ADDENDUM NO. ONE (1)

REHABILITATE TAXIWAY LIGHTING

CLEARFIELD-LAWRENCE TOWNSHIP AIRPORT
CLEARFIELD, PENNSYLVANIA

PENNDOT AGREEMENT NO. ABG-2022-CLTJAA-00017
DELTA PROJECT NO. 22065

LED RETROFIT DETAIL FOR TAXIWAY EDGE LIGHT

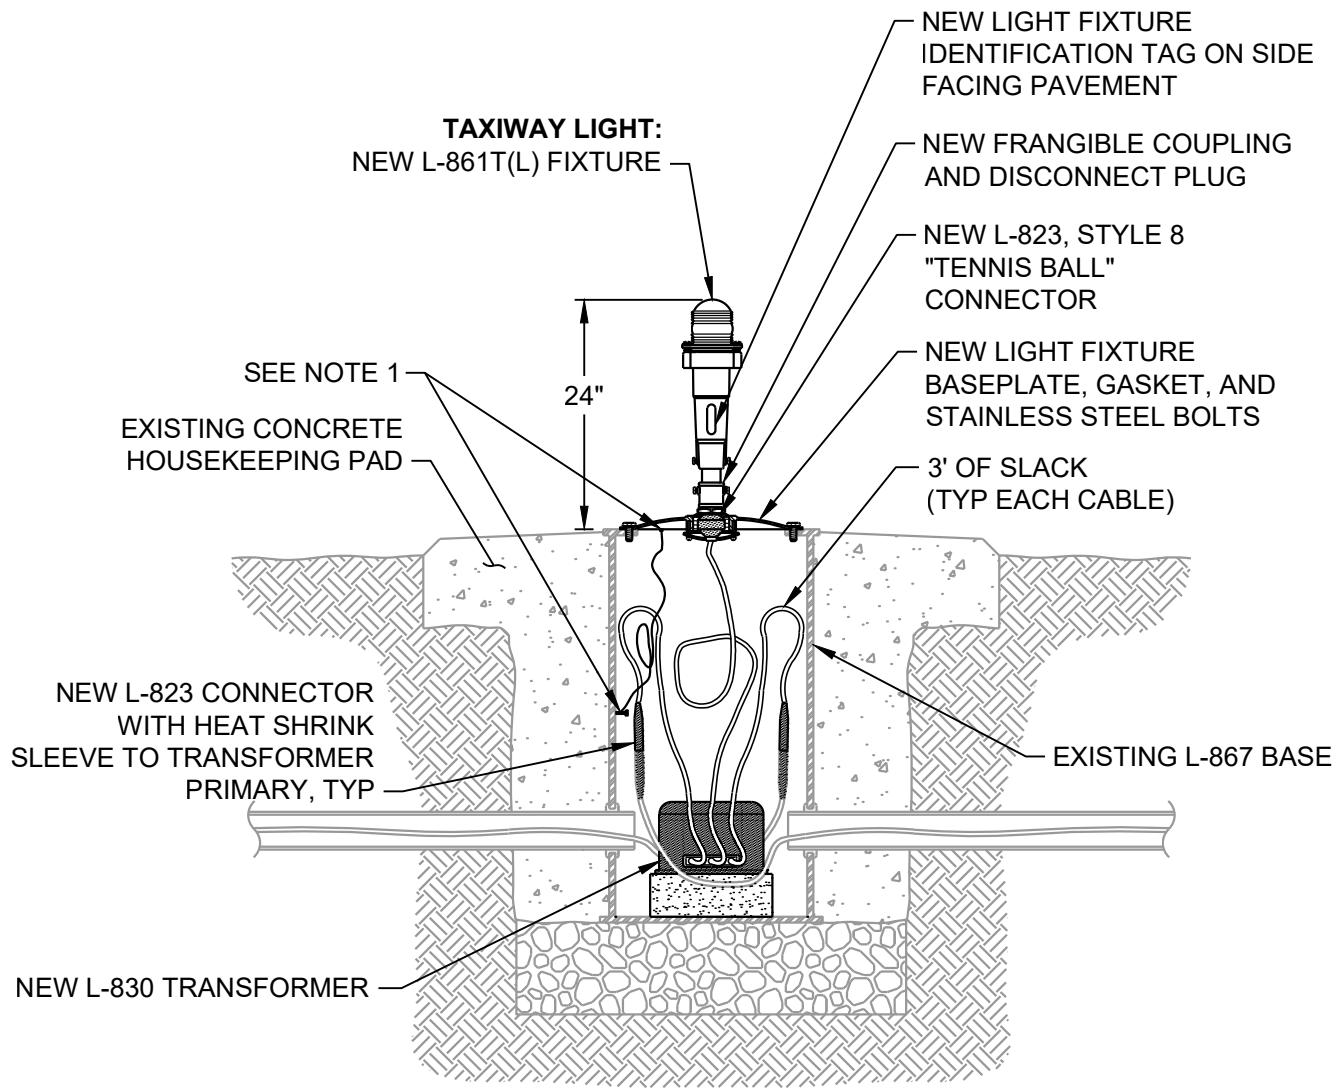
3. **REPLACE** the LED RETROFIT DETAIL FOR TAXIWAY EDGE LIGHT detail with the attached “Exhibit No. 10-1” of Addendum No. One (1). A Revised Sheet will be issued to the successful bidder.

15. **QUESTION:** Are new base plates required for the new lights?
- ANSWER:** The Plan details have been revised by this Addendum No. One (1) to require that new base plates, gaskets, bolts, cable connector kits and connections, and ground connection between the new base plate and the existing L-867 base be included in the price for the new light fixtures. No additional payment will be made.

1. MECHANICALLY BOND NEW LIGHT FIXTURE BASEPLATE TO EXISTING L-867 BASE USING MANUFACTURER-PROVIDED LUGS WITH #6 COPPER GROUND (600V RATING) WITH GREEN XHHW INSULATION (BRAIDED GROUND STRAP OF EQUAL RATING ACCEPTABLE) WITH LENGTH SUFFICIENT TO EASILY REMOVE LIGHT BASEPLATE FOR MAINTENANCE (NO SEPARATE PAY).
2. ALL CABLE, CONNECTIONS AND OTHER ITEMS AND WORK REQUIRED TO COMPLETE THE INSTALLATION ARE INCIDENTAL TO THE COST OF THE LIGHT FIXTURE. THERE WILL BE NO SEPARATE PAYMENT FOR ANY MATERIALS, EQUIPMENT OR LABOR ASSOCIATED WITH MAKING THE NEW LIGHT FIXTURE FULLY FUNCTIONAL.
